Arunima Sportswear Ltd (Extension)

27 August 2023

Observations

3.4.4 Earthquake Load (E)

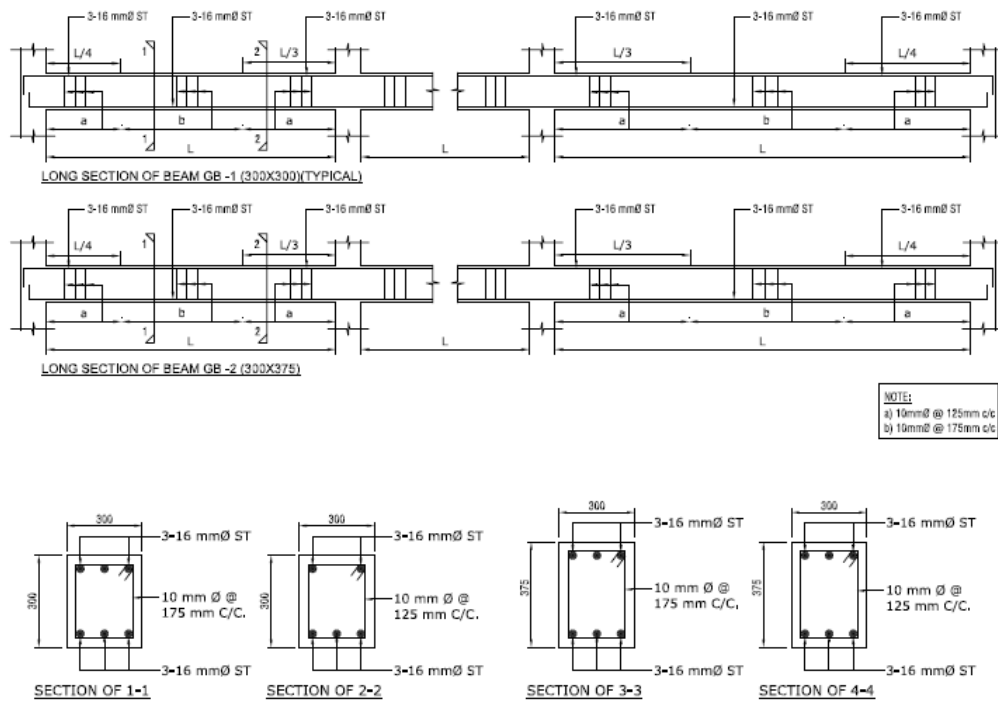
Detail seismic load calculation not included in the design report.

Response modification co-efficient factor R considered for Special steel concentrically braced frames, but no calculation provided in the design report.

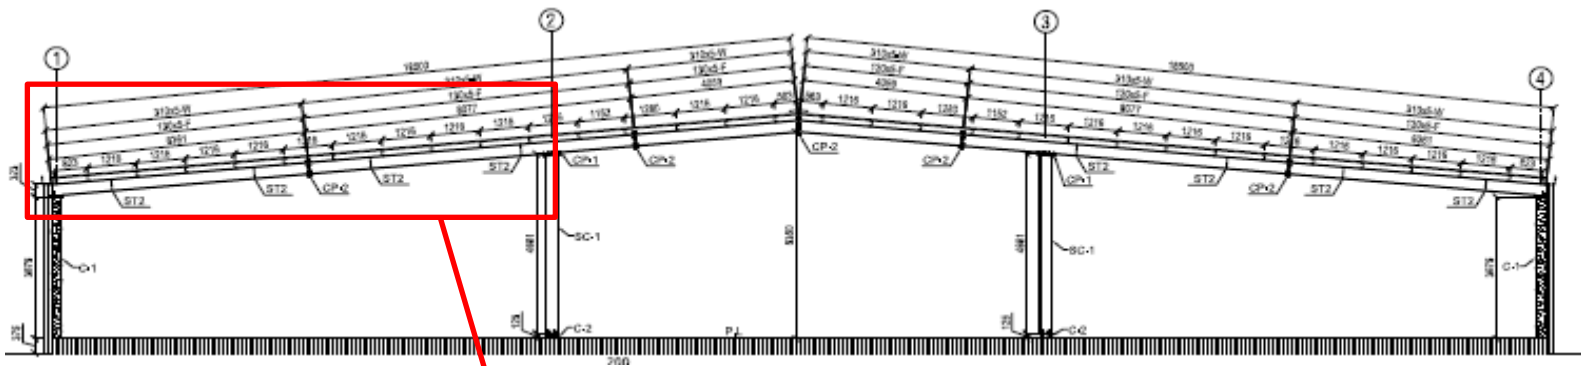
Detail calculation and adequacy check of lateral serviceability not included in the design report. Building engineer is required to check the lateral stability of the shed.

Unsupported long rafter

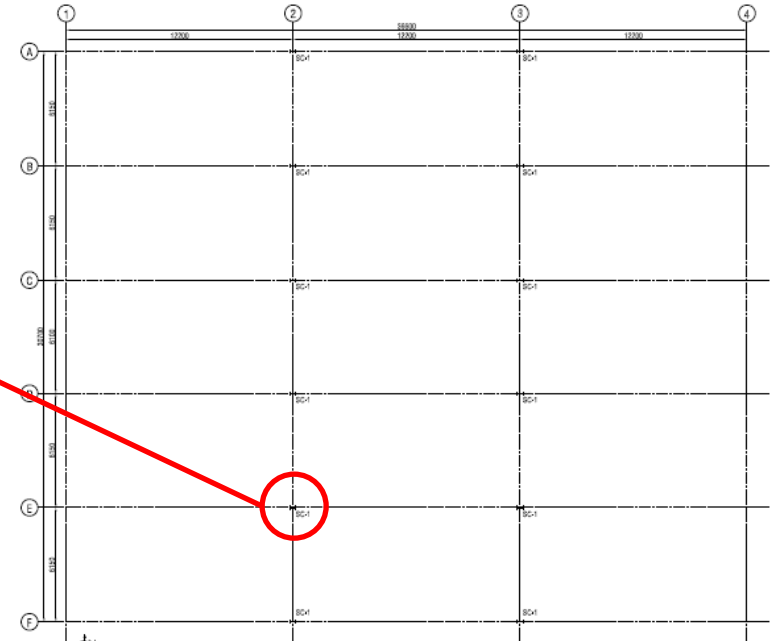
The rafter unsupported length is much higher considering the size of rafter section, which can cause local buckling failure in the rafter. The building Engineer is required to check the capacity of the rafter for local buckling failure.
